May 26, 2021

**RE: MUSSEY GRADE ROAD ALLIANCE COMMENTS ON 2023-2025 WILDFIRE  
MITIGATION PLANS OF PG&E, SCE, AND SDG&E**

**Figure 12** - PG&E circuit risk rankings as determined by WDRM v2 and WDRM v3, as shown by data in PG&E's 60 day revision response

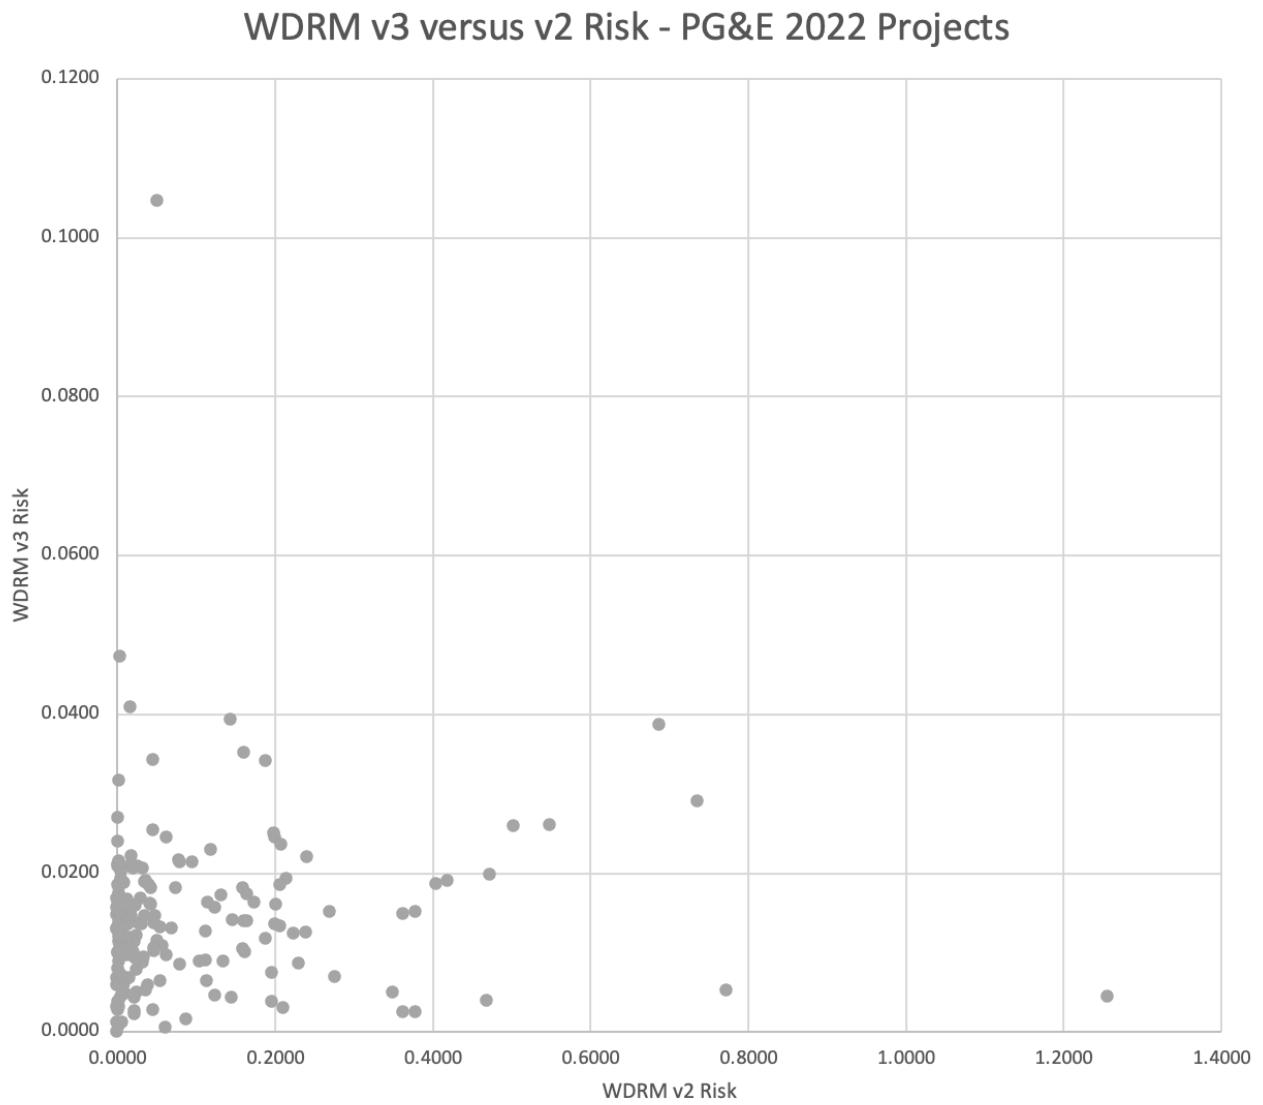
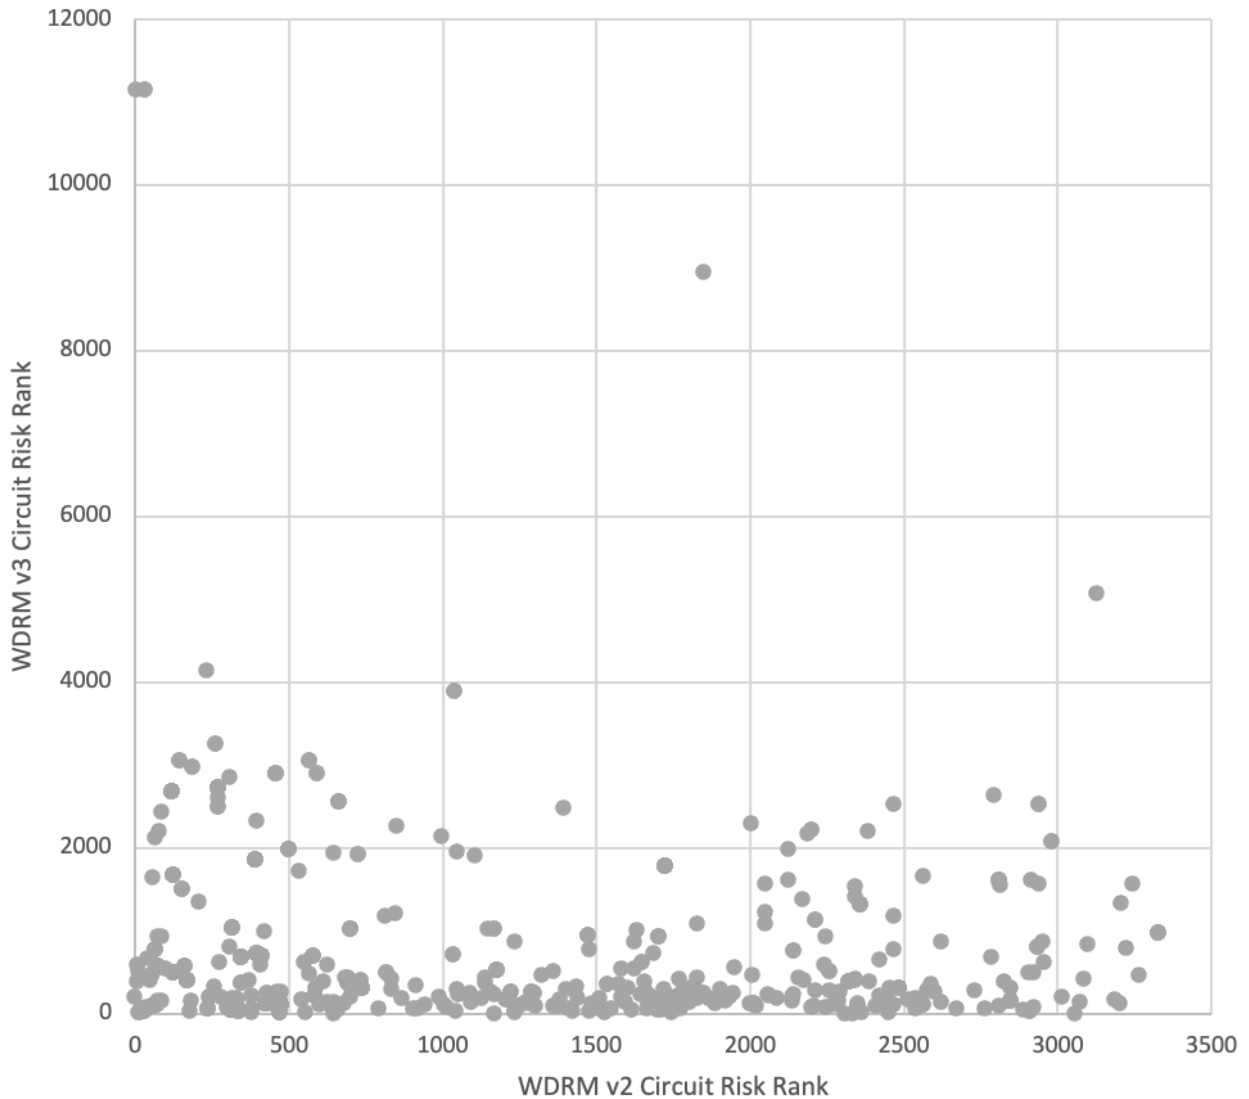
The point that MGRA stressed in its comments and in its PG&E GRC testimony is that PG&E's risk models are in flux and rapidly developing. However, PG&E is using these risk models to plan billions of dollars' worth of infrastructure changes, particularly undergrounding.

**Figure 14 - Figure PG&E-6.2.2-9 showing WDRM v3 consequence scores for the PG&E service area<sup>122</sup>**

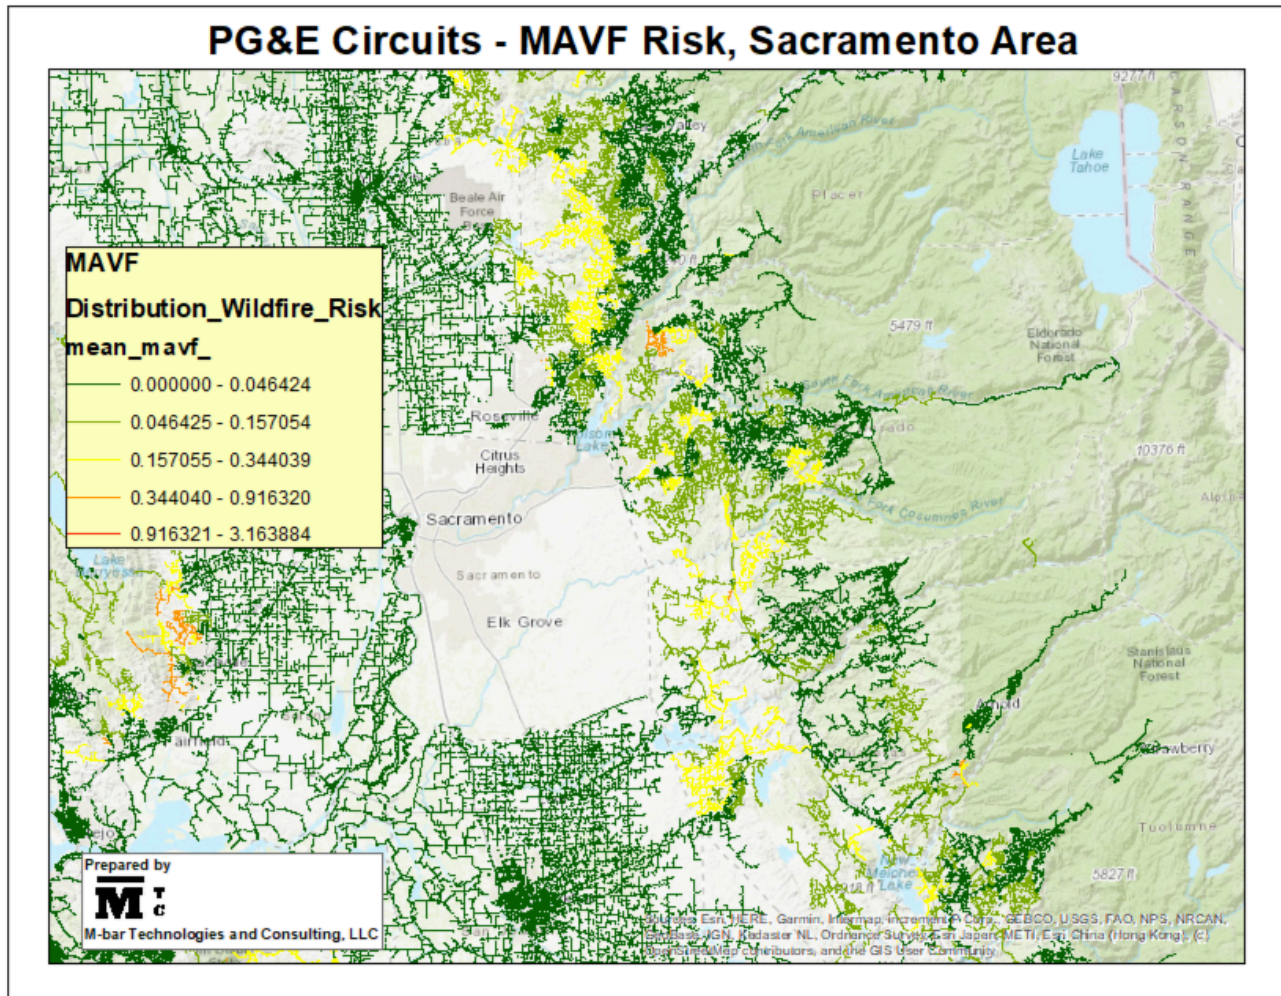
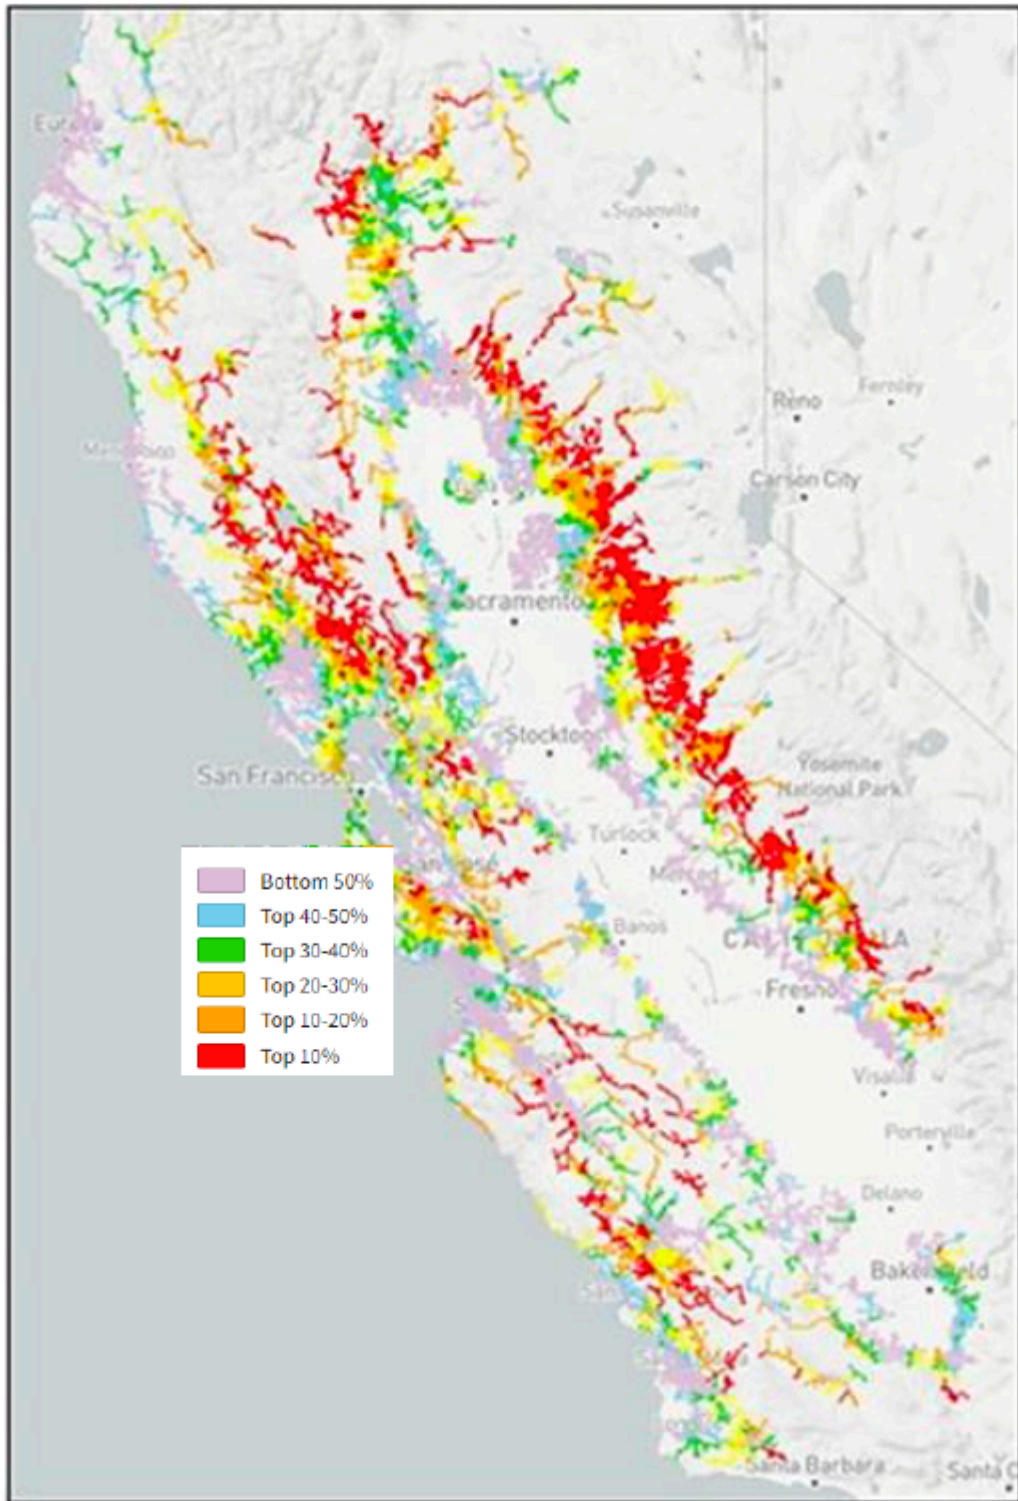
This is not to imply that every point will have the same consequence, since PG&E will run weather history for each of those points at it will fall into different bins on different historical days. PG&E claims that by utilizing this method it is properly incorporating “worst case” weather days.<sup>121</sup> This approach appears to address the counterintuitive result shown in Figure 13, as shown in Figure PG&E-6.2.2-9:

**Figure 15** - Fine grained detail of PG&E's POI model from a typical location. Pixels range from green (low risk) to red (high risk).

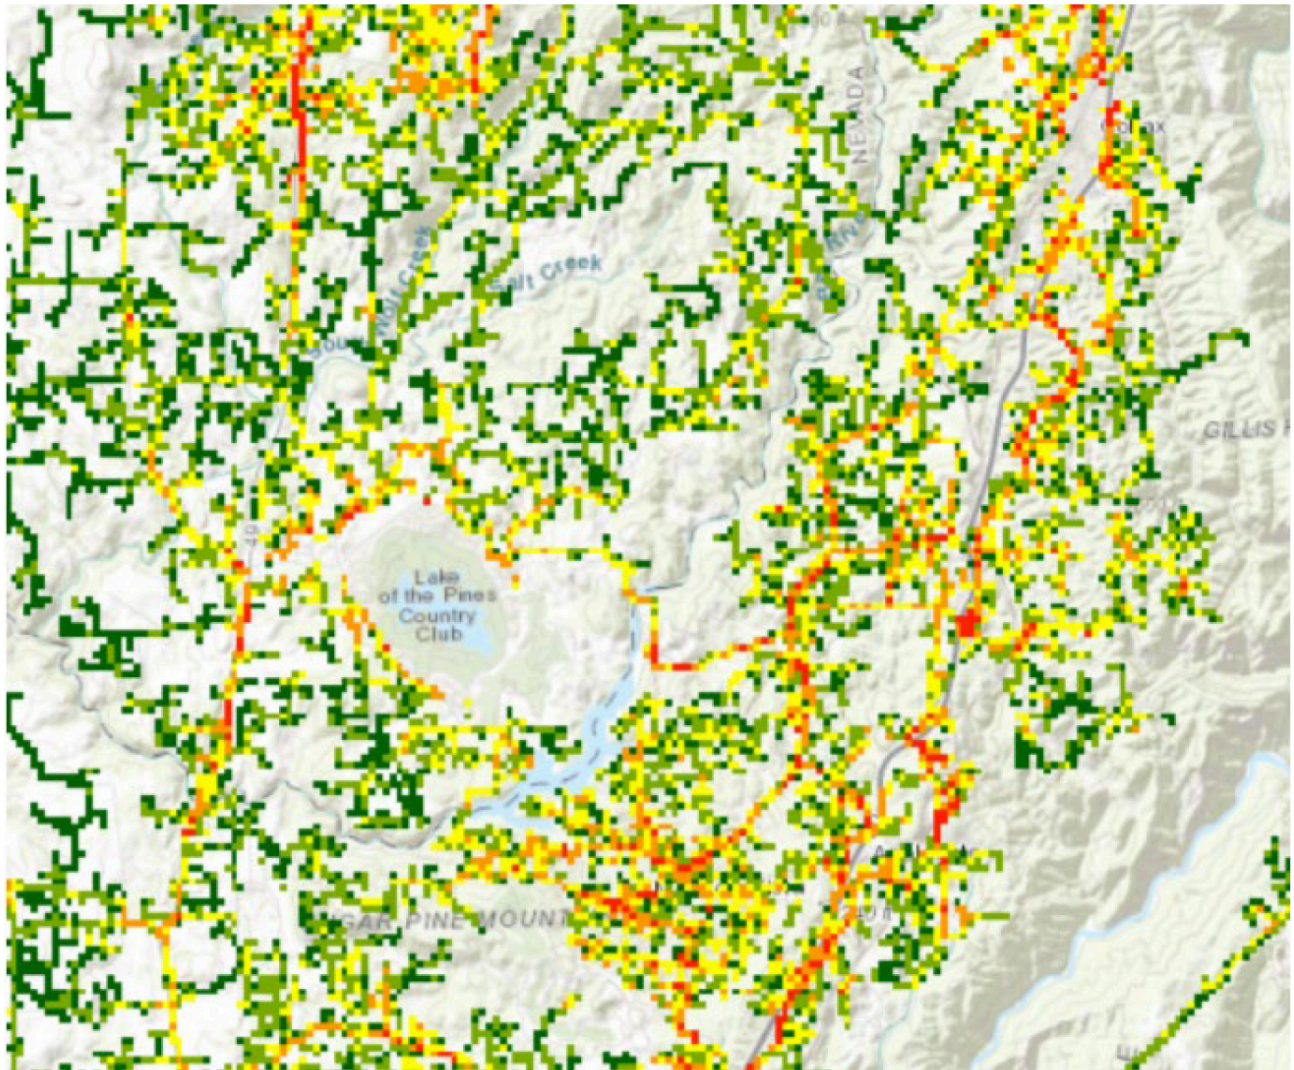
As can be seen, there is considerable variation over very short distances. As PG&E explains, *“Fine grained localization may result where locations of significant covariate variability exist in PG&E’s service territory (e.g. a heavily forested area next to a non-forested area).”*<sup>126</sup> PG&E also

**Figure 16** - SCE circuit-level risk scores based upon SCE's response to MGRA Data Request 2 Question 2. SCE has aggregated its segment-level risk scores into averaged circuit-level risk scores.

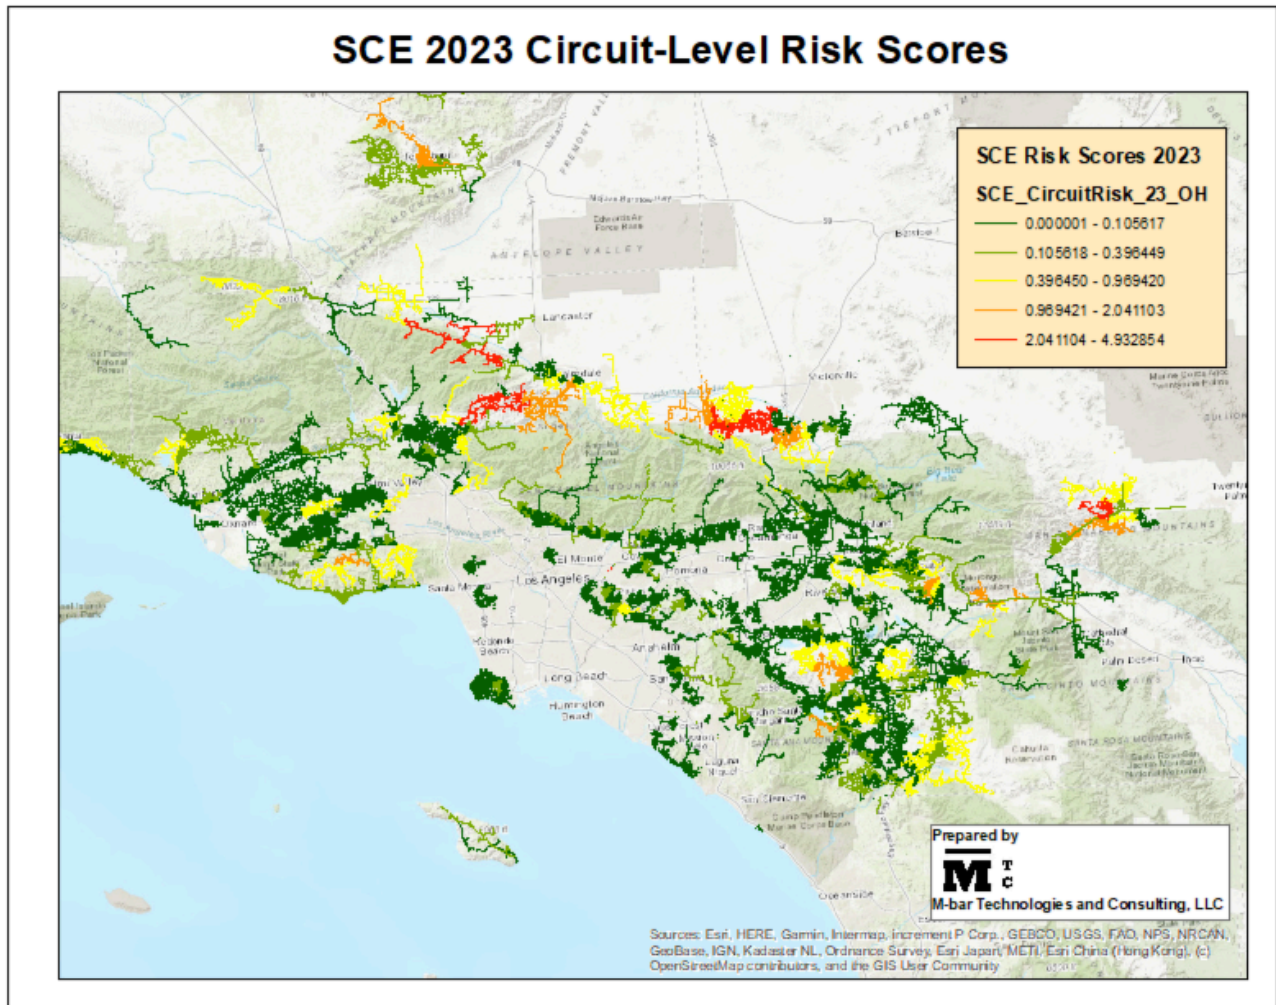
For this figure, MGRA used a geodatabase provided as SCE's response to its Data Request 2, Question 2. This database aggregates segment-level risk into averages for each SCE circuit, and provides general insight into what areas SCE considers to be highest risk. The area is shown in the figure is the greater Los Angeles, Ventura, and Orange County areas. As can be seen, SCE finds its highest risk in this area on the northern slopes of the San Gabriel mountains. This makes sense, since Foehn wind events starting in these areas could spread widely before descending into the LA basin and foothill communities.

**Figure 17** - The ratio of SCE circuit-level ignition probability in 2023 to the ignition probability for 2022. Green circuits indicate a reduction in ignition probability, while yellow, orange, and red circuits indicate an increase in the estimated ignition probability.

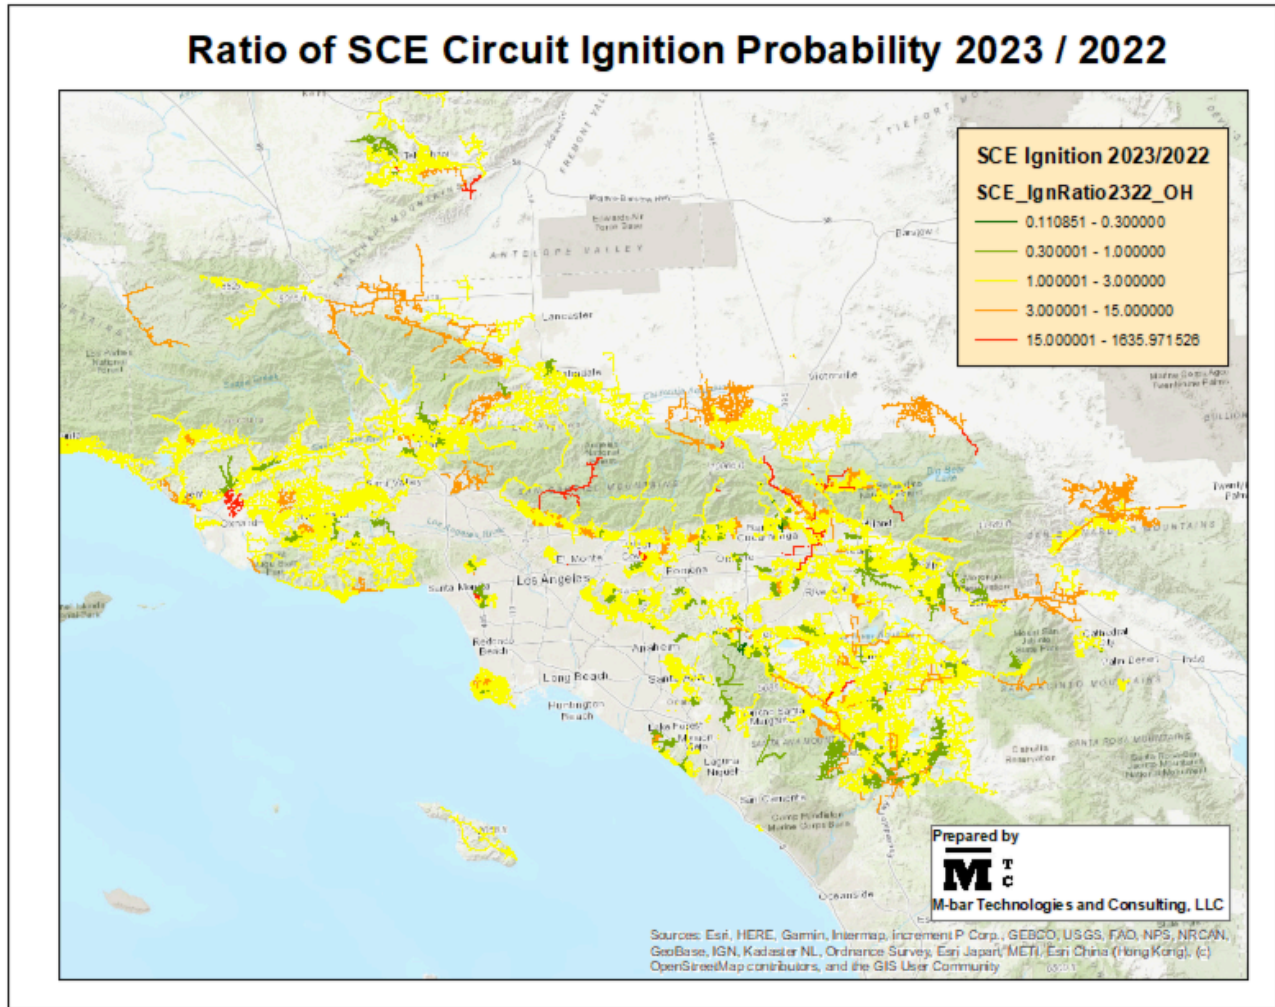
Figure 17 shows that overall, the ignition probability calculated by MARS increased over the SCE service area. The greatest increases shown in the figure were in the San Gabriel mountains and on their northern slopes and foothills.

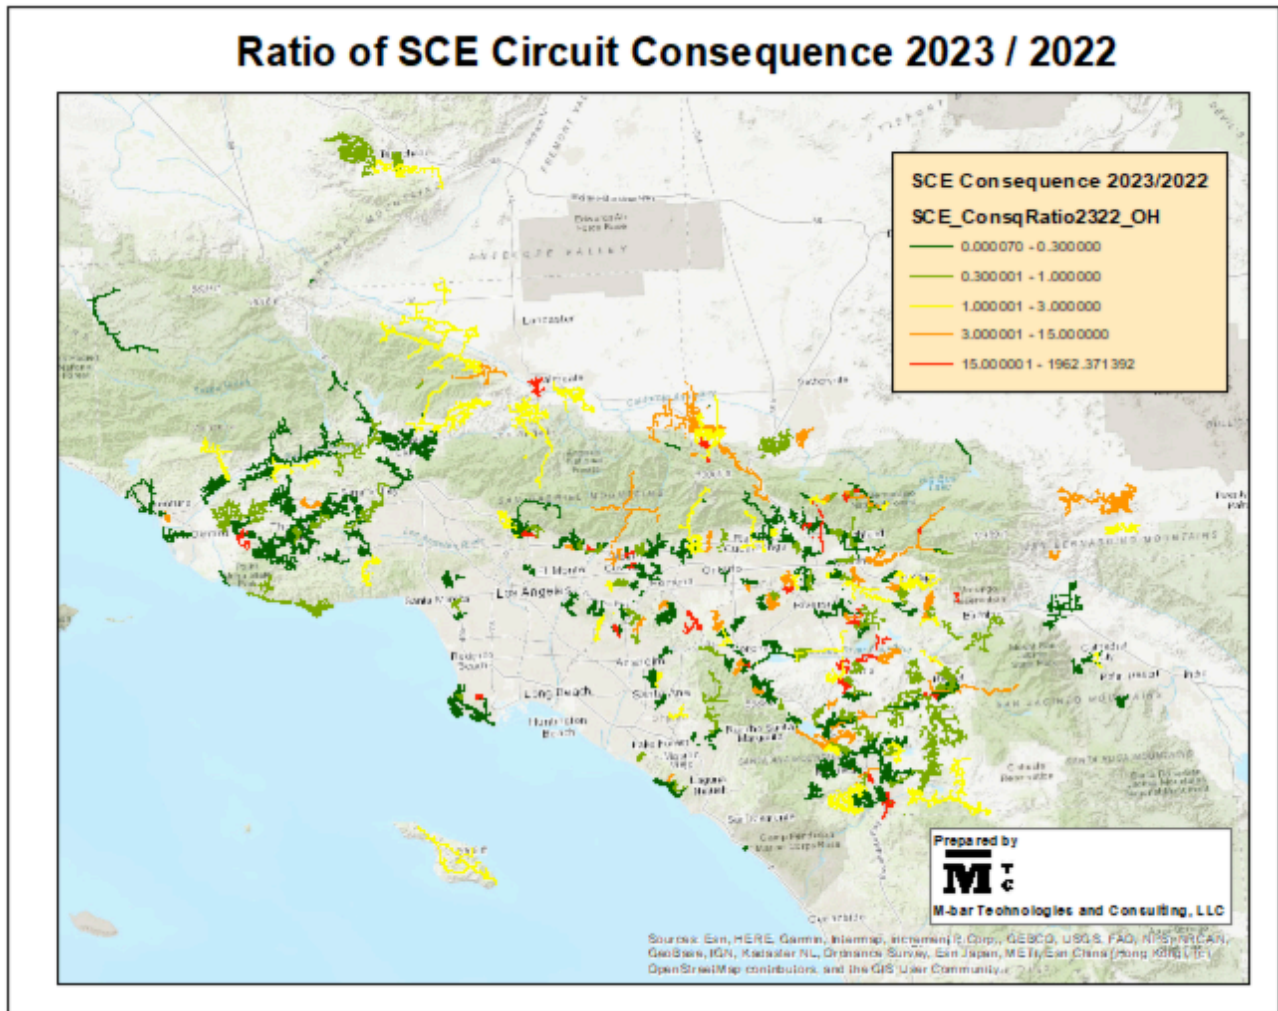
As readily apparent, some circuits visible in the other figures are missing. This is likely an artifact of the file provided by SCE, which had 2022 consequence values set to zero for a number of circuits. Nevertheless, some trends can be noted. In general, while many consequence circuit values changed substantially, increases and decreases were fairly balanced and do not show obvious geographical distributions. However, the area of the San Gabriel mountains and northern foothills shows more substantial increases, further reinforcing the elevated risk in these areas indicated in Figure 16.
